Access Compliance Report Public Rights-of-Way (Pedestrian Signals)

Main Street: **SENDERO_WAY** Cross Street: **ANTONIO_PKWY** Location: **SE**

ADA ID: **SGRK211116132539** Signal Type: **One Push Button-Non APS** Overall Compliance: **No** Severity Scores: **BTN 1: 10 BTN 2: N/A No BTN: N/A**

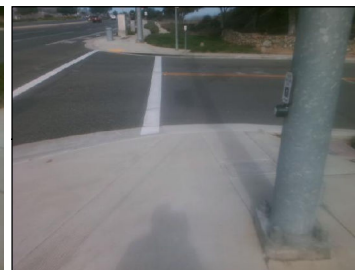
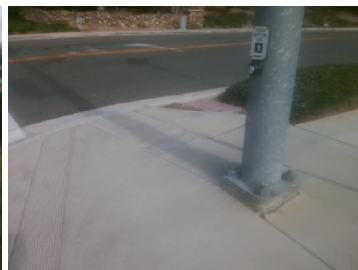
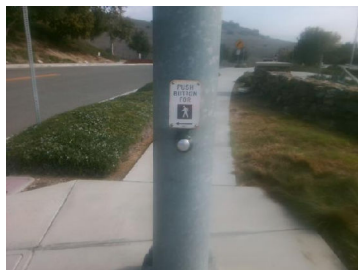
N/A Is Button 1 APS or Non-APS?	NonAPS	N/A Is Button 2 APS or Non-APS?	N/A
N/A B 1 VibroTact Arrow?	N/A	N/A B 2 VibroTact Arrow?	N/A
N/A B 1 VibroTact Parallel to Xing?	N/A	N/A B 2 VibroTact Parallel to Xing?	N/A
N/A B 1 VibroTact Contrast	N/A	N/A B 2 VibroTact Contrast	N/A
No B 1 Pilot Light?	No	N/A B 2 Pilot Light?	N/A
N/A B 1 Pilot Light Illumination?	N/A	N/A B 2 Pilot Light Illumination?	N/A
N/A B 1 Walk Indicator Type	N/A	N/A B 2 Walk Indicator Type	N/A
N/A B 1 Walk Indicator Audible?	N/A	N/A B 2 Walk Indicator Audible?	N/A
N/A B 1 Locator Tone?	N/A	N/A B 2 Locator Tone?	N/A
N/A B 1 Tone Audible Range?	N/A	N/A B 2 Tone Audible Range?	N/A
B 1 Addl APS Features?	No	B 2 Addl APS Features?	N/A
B 1 Addl APS Features Notes	N/A	B 2 Addl APS Features Notes	N/A

Compliance	Description	Data	Compliance	Description	Data
Button Count		Button1	Yes	Distant to Additional Button (in)	204
Additional Button Present?		Yes	N/A	Additional Button ID	SGRK211116132649
Located In An Island/Median?		No			
N/A B 1 Sign Present?		Yes	N/A	B 2 Sign Present?	N/A
Yes B 1 Sign Purpose?		Yes	N/A	B 2 Sign Purpose?	N/A
Yes B 1 Sign Lettering & Contrast?		Yes	N/A	B 2 Sign Lettering & Contrast?	N/A
Yes B 1 Parallel To XWalk?		Yes	N/A	B 2 Parallel To XWalk?	N/A
N/A B 1 PAR to Button?		N/A	N/A	B 2 PAR to Button?	N/A
N/A B 1 PAR to XWalk?		N/A	N/A	B 2 PAR to XWalk?	N/A
Yes B 1 Clear Floor Space?		Yes	N/A	B 2 Clear Floor Space?	N/A
N/A B 1 FWD Approach?		N/A	N/A	B 2 FWD Approach?	N/A
N/A B 1 FWD Approach Constrained?		N/A	N/A	B 2 FWD Approach Constrained?	N/A
N/A B 1 FWD Approach Reach (in)		N/A	N/A	B 2 FWD Approach Reach (in)	N/A
N/A B 1 FWD Approach Width (in)		N/A	N/A	B 2 FWD Approach Width (in)	N/A

N/A B 1 FWD Approach Obstruction?		N/A	N/A	B 2 FWD Approach Obstruction?	N/A
N/A B 1 FWD Approach Obstruction Dist (in)		N/A	N/A	B 2 FWD Approach ObstructionDist (in)	N/A
N/A B 1 PARA Approach?		N/A	N/A	B 2 PARA Approach?	N/A
N/A B 1 PARA Approach Constrained?		No	N/A	B 2 PARA Approach Constrained?	N/A
Yes B 1 PARA Approach Reach (in)		0	N/A	B 2 PARA Approach Reach (in)	N/A
N/A B 1 PARA Approach Width (in)		N/A	N/A	B 2 PARA Approach Width (in)	N/A
N/A B 1 PARA Approach Obstruction?		No	N/A	B 2 PARA Approach Obstruction?	N/A
N/A B 1 PARA Approach Obstruction Dist (in)		N/A	N/A	B 2 PARA Approach Obstruction Dist (in)	N/A
Yes B 1 Clear Floor Space Slope (%)		0.3	N/A	B 2 Clear Floor Space Slope (%)	N/A
Yes B 1 Clear Floor Space XSlope (%)		1.7	N/A	B 2 Clear Floor Space XSlope (%)	N/A
N/A B 1 PAR Slope (%)		0.9	N/A	B 2 PAR Slope (%)	N/A
Yes B 1 Height (in)		39	N/A	B 2 Height (in)	N/A
Yes B 1 Pressure (#)		5	N/A	B 2 Pressure (#)	N/A

Yes B 1 Closed Fist Operation?		Yes	N/A	B 2 Closed Fist Operation?	N/A
Yes B 1 Diameter (in)		2	N/A	B 2 Diameter (in)	N/A
N/A B 1 Crossing Direction		N	N/A	B 2 Crossing Direction	N/A
No B 1 DistanceTo XWalk (in)		62	N/A	B 2 DistanceTo XWalk (in)	N/A
No B 1 DistanceTo Curb (in)		130	N/A	B 2 DistanceTo Curb (in)	N/A
Parcel Identification Number		741-571-28			
Google Street View Link					
http://www.google.com/maps/@?api=1&map_action=pano&viewpoint=33.52893857,-117.61880552

Possible Solutions: Replace Signal Push Button With APS Button. Remove & Relocate Sign.
